BUILDING CODE OF AUSTRALIA COMPLIANCE ASSESSMENT REPORT

EARLY CHILDCARE CENTRE WITH BASEMENT CARPARKING

16 TERRY ROAD, EASTWOOD

REPORT NO. ► 13089 Rev 3.1

Figure 1: Section detailing effective height

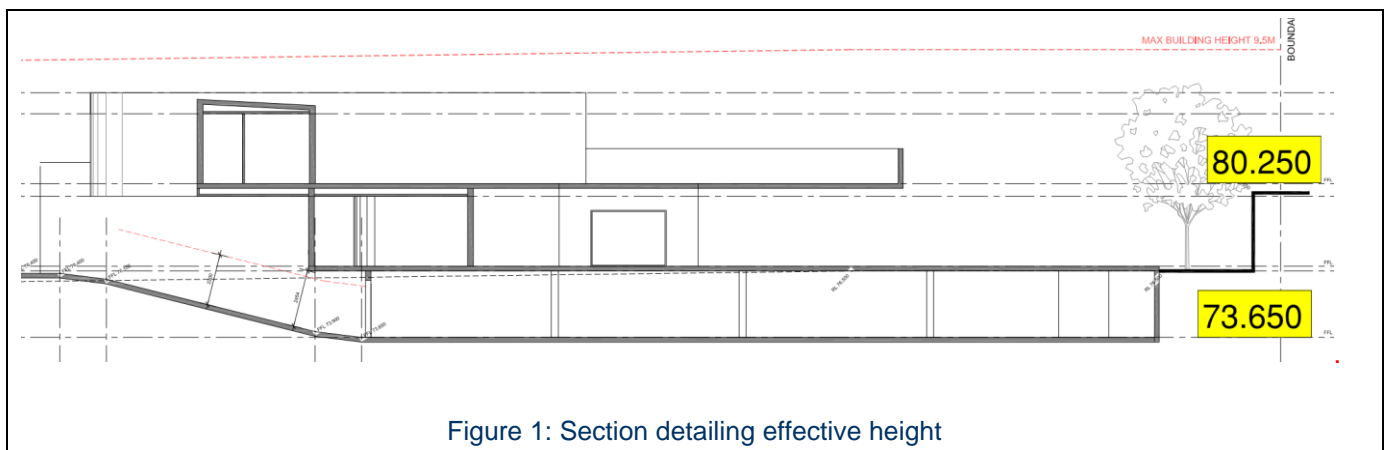
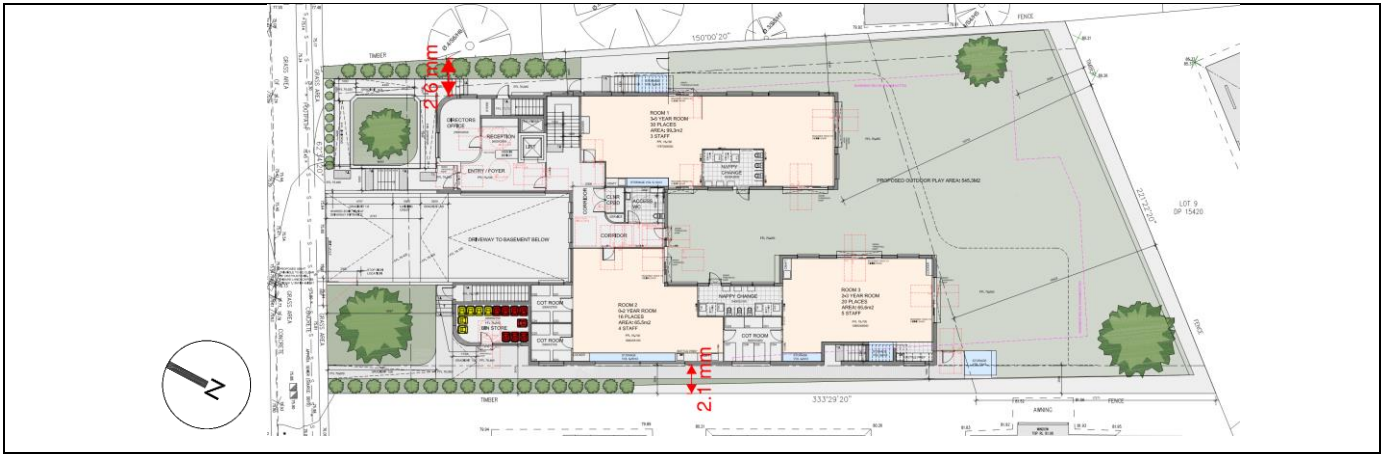
3.2 Assessment of Effective Height

Basement

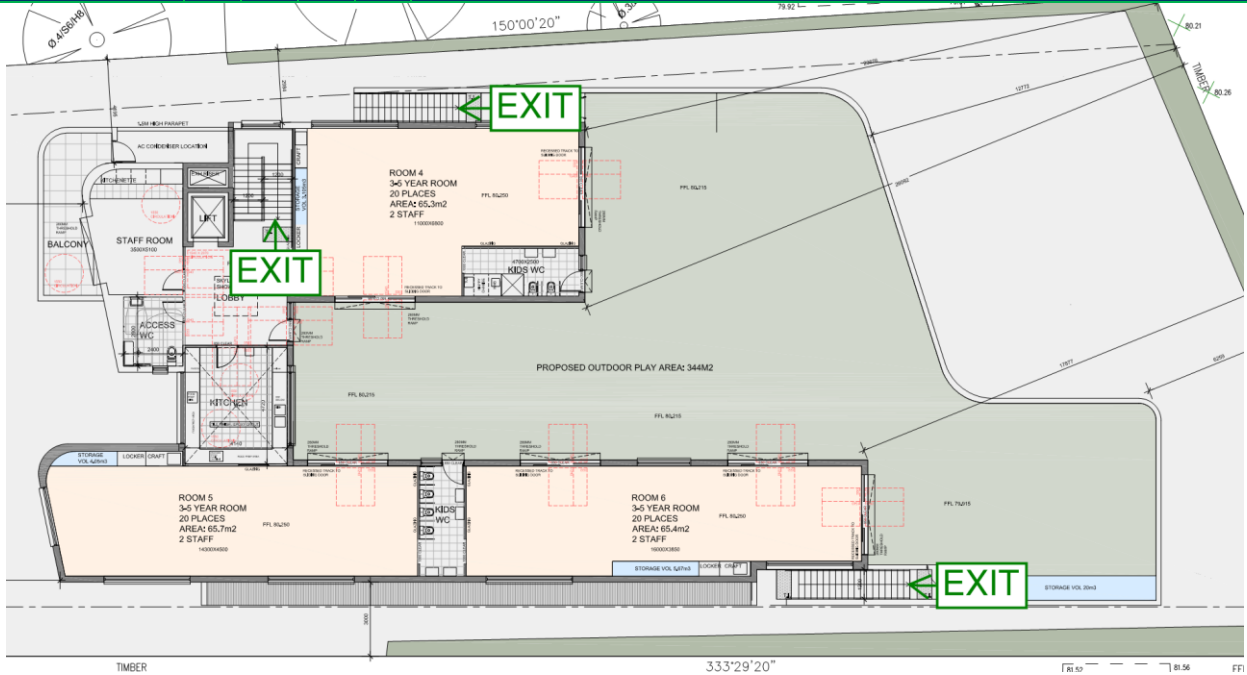
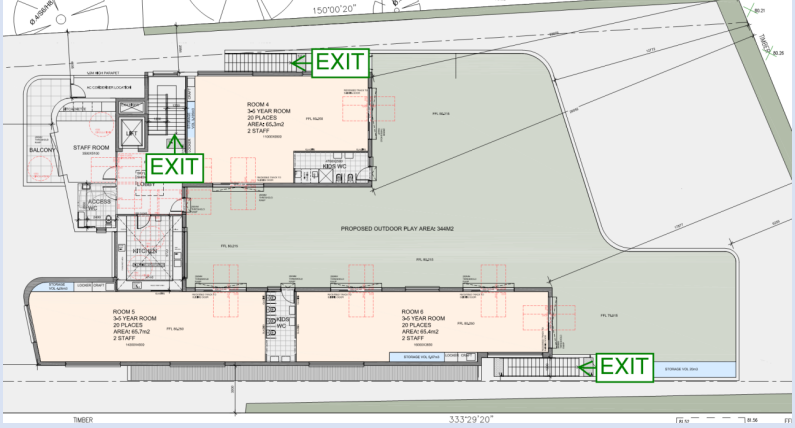
D2D4 When fire-isolated stairways and ramps are required [2019: D1.3]	X	(2) Class 7, 9 buildings — Every stairway or ramp serving as a required exit must be fire-isolated unless— (c) in any other case, except in a Class 9b early childhood centre, it connects, passes through or passes by not more than 2 consecutive storeys and one extra storey of any classification may be included if— (i) the building has a sprinkler system (other than a FPAA101D system) complying with Specification 17 installed throughout; or (ii) the required exit does not provide access to or egress for, and is separated from, the extra storey by construction having— (A) an FRL of -/60/60, if non-loadbearing; and (B) an FRL of 90/90/90 for Type A construction; and (C) no opening that could permit the passage of fire or smoke.
<p><u>COMPLIANCE COMMENTARY</u></p> <p>The stairways serving as required exits are not fire-isolated as required.</p> <p>Stairways serving the carpark are required to be fire-isolated to achieve travel distance DTS compliance.</p>

Basement

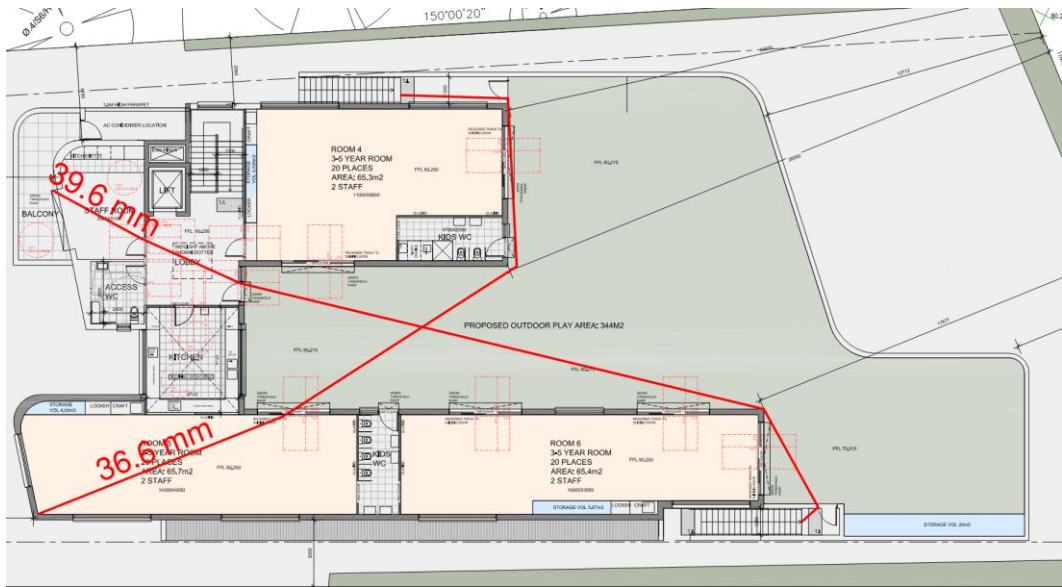
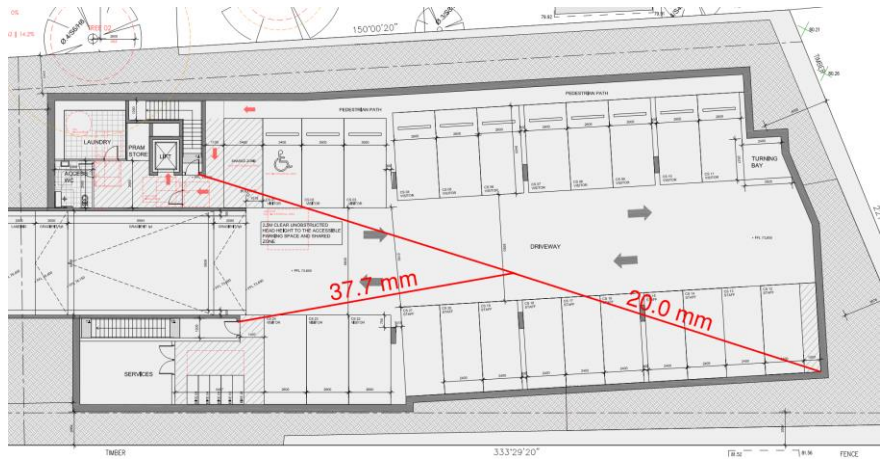
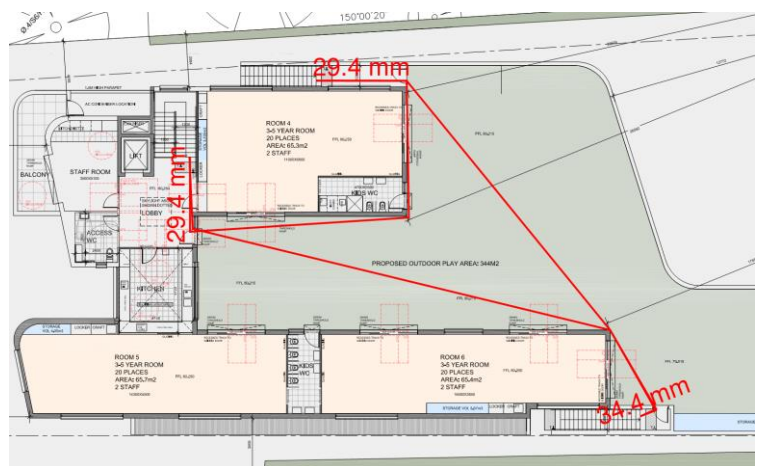
D2D6					<p>X Exits that are required as alternative means of egress must be—</p> <ul style="list-style-type: none"> (a) distributed as uniformly as practicable within or around the storey served and in positions where unobstructed access to at least 2 exits is readily available from all points on the floor including lift lobby areas; and (b) not less than 9 m apart; and (c) not more than— <ul style="list-style-type: none"> (iii) in all other cases — 60 m apart; and (d) located so that alternative paths of travel do not converge such that they become less than 6m apart. <p>COMPLIANCE COMMENTARY</p>
Distance between alternative exits [2019: D1.5]
